APPLICATION NO.	FILING DATE	FIRST NAMED INVENTOR	ATTORNEY DOCKET NO.	CONFIRMATION NO.
10/511,294	10/15/2004	Klaus Lenhart	2502 0166US	2233
23373	7590	12/28/2007	EXAMINER	
SUGHRUE MION, PLLC 2100 PENNSYLVANIA AVENUE, N.W. SUITE 800 WASHINGTON, DC 20037			GARCIA, ERNESTO	
		ART UNIT	PAPER NUMBER	
		3679		
		MAIL DATE	DELIVERY MODE	
		12/28/2007	PAPER

Office Action Summary	Application No.	Applicant(s)
	10/511,294	LENHART, KLAUS
	Examiner	Art Unit
	Ernesto Garcia	3679

DETAILED ACTION

Figure 1 of Applicant's invention showing the drawing problem

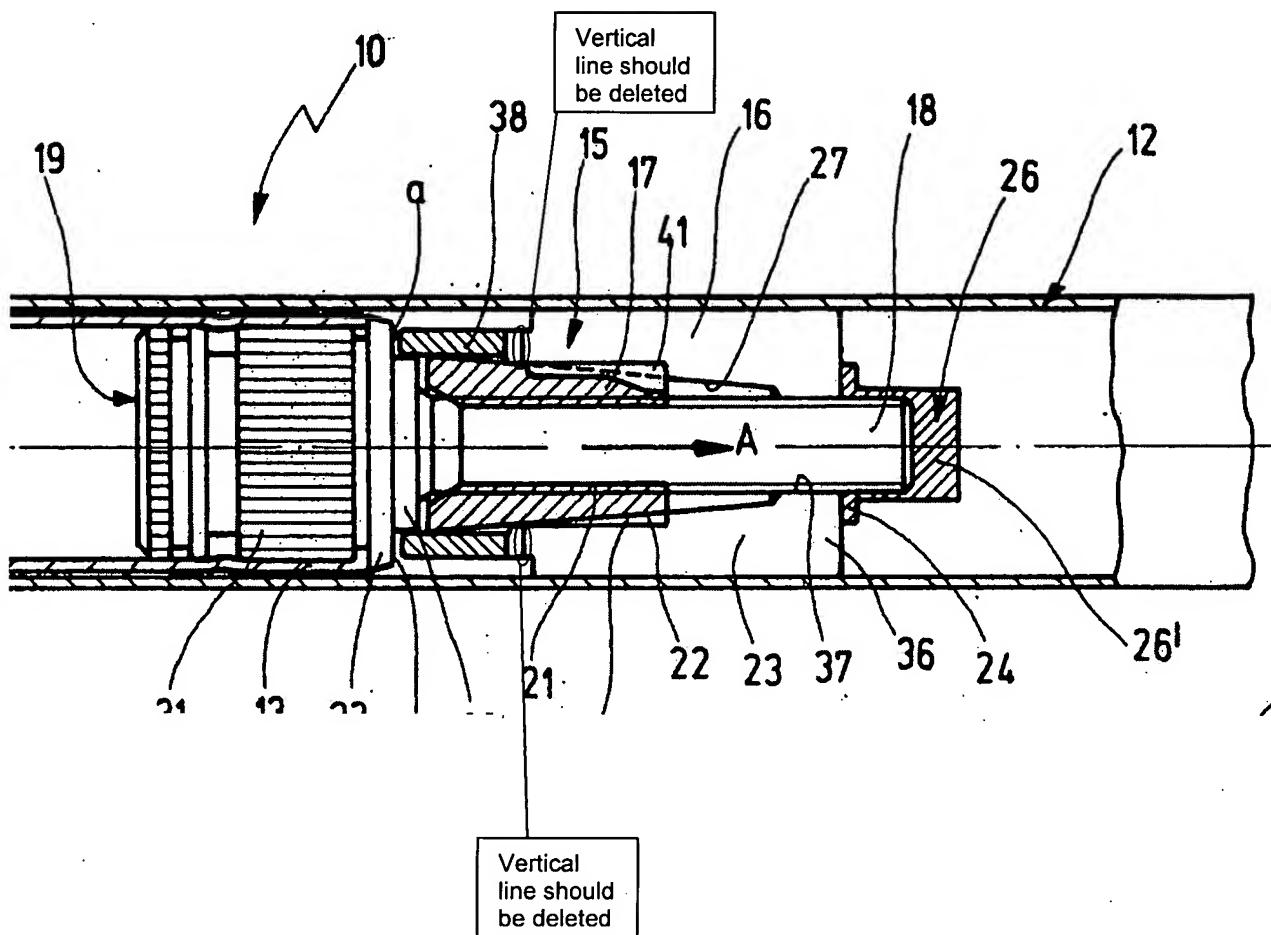
The drawings are objected to because some of the reference characters in Figure 3 contain brackets. Note that brackets cannot be associated with reference characters. See 37 CFR 1.84(p)(1). Further, since Figure 3 is a cross-section of Figure 2, reference characters "144" and "146" should not be in Figure 3 since these do not appear in Figure 1 or Figure 2. Figure 1 contains a minor discrepancy which makes the slot 43 appear as ending too short from the cylindrical shoulder 38. See the attachment of Figure 1 since the examiner identifies the vertical lines that need to be deleted from the slots 43 .

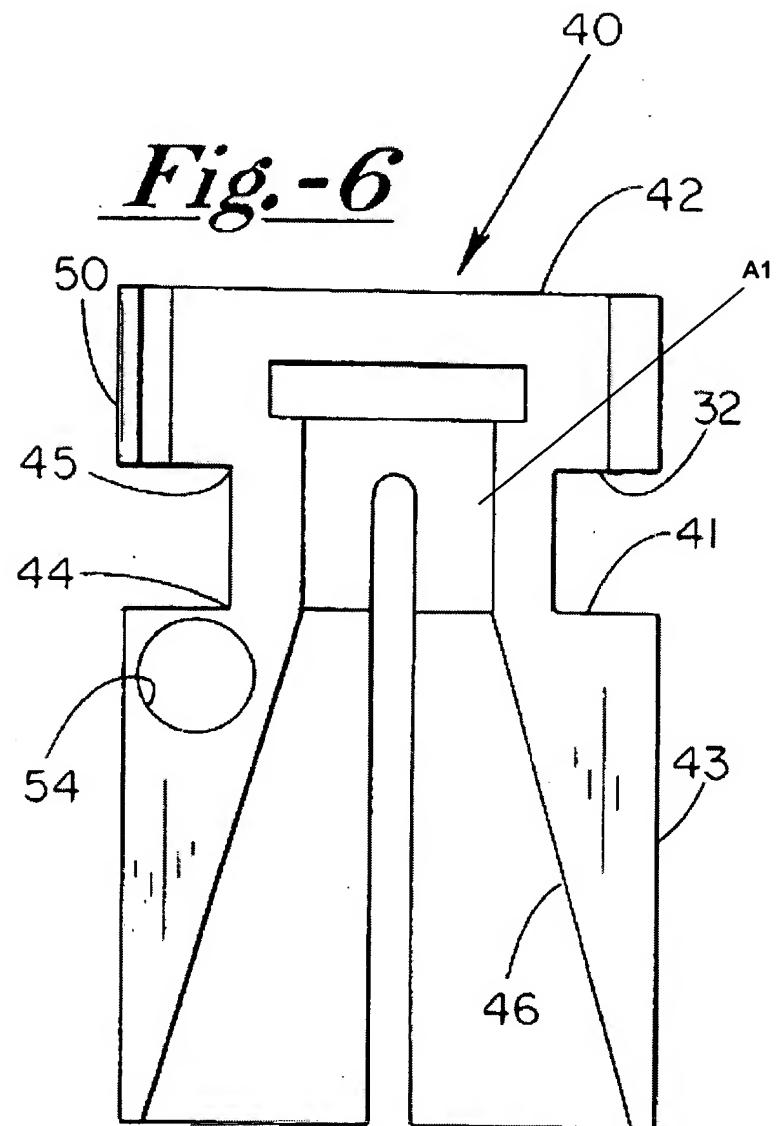
11 and supported in a rotationally fixed manner on the end of the inner tube 12. A limit stop (the head of the screw) is disposed on the free end of the adjusting screw 32A. The spreading element 32 is radially spreadable and has a non-threaded bore A1 (see marked-up attachment) and only a single inner cone 46. The inner cone 46 opens towards the end of the inner tube 12. The interior element 31 has an outer cone 34 structured, dimensioned, and disposed for cooperation with the inner cone 46. The interior element 31 has an internal threaded bore 36 cooperating with the adjusting screw 32A. The spreading element 32 and the interior element 31 cooperate and form a spreading device axially supported at the end of the inner tube 12. However, Lindemann et al. fail to disclose an inner limit stop being disposed at the end of the inner tube 12, and the spreading element 32 being disposed between the limit stop 14, disposed at the end of the inner tube 12, and the limit stop 25 disposed on the free end of the adjusting screw 32A..

Fig. 11

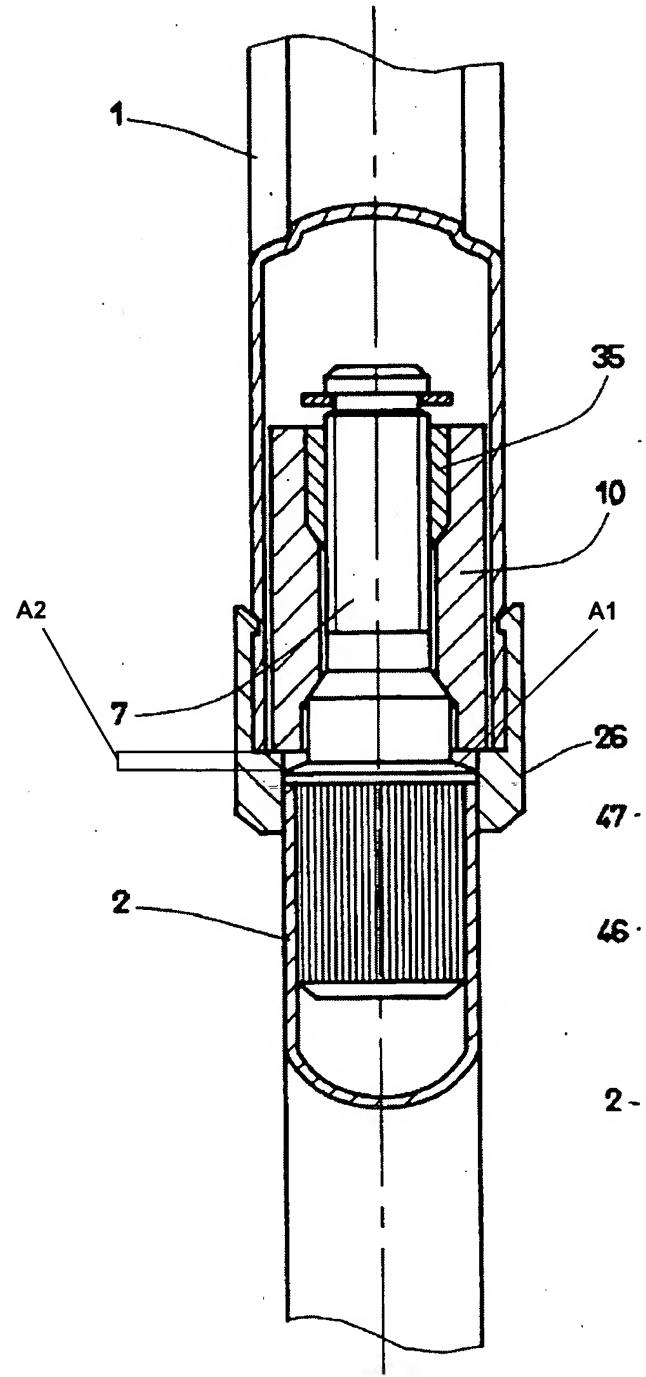
Regarding claim 18, Simond discloses, in Figure 11, an adjustable-length pole comprising at least one outer tube 1, an inner tube 2 structured, an adjusting screw 7, a limit stop A1 (see marked-up attachment) disposed at an end of the inner tube 2, a limit stop (the C-clip) disposed at a free end of the adjusting screw 7, and a spreading device 10,35. The adjusting screw 7 is axially oriented within the outer tube 1 and supported in a rotationally fixed manner on the end of the inner tube 2. The spreading device 10,35 comprises an interior portion 35 and a radially spreadable portion 10. The interior

portion **35** is threaded. The radially spreadable portion **10** is not-threaded and separated from the limit stop **A1** disposed at the end of the inner tube **2** by a pre-established slight distance or gap **A2**. Note that the spreadable portion is able to move axially within narrow limits without rotation thereof in response to an axial force forcing the inner tube further into the outer tube and applying a radial force against an inner surface of the outer tube **1**.
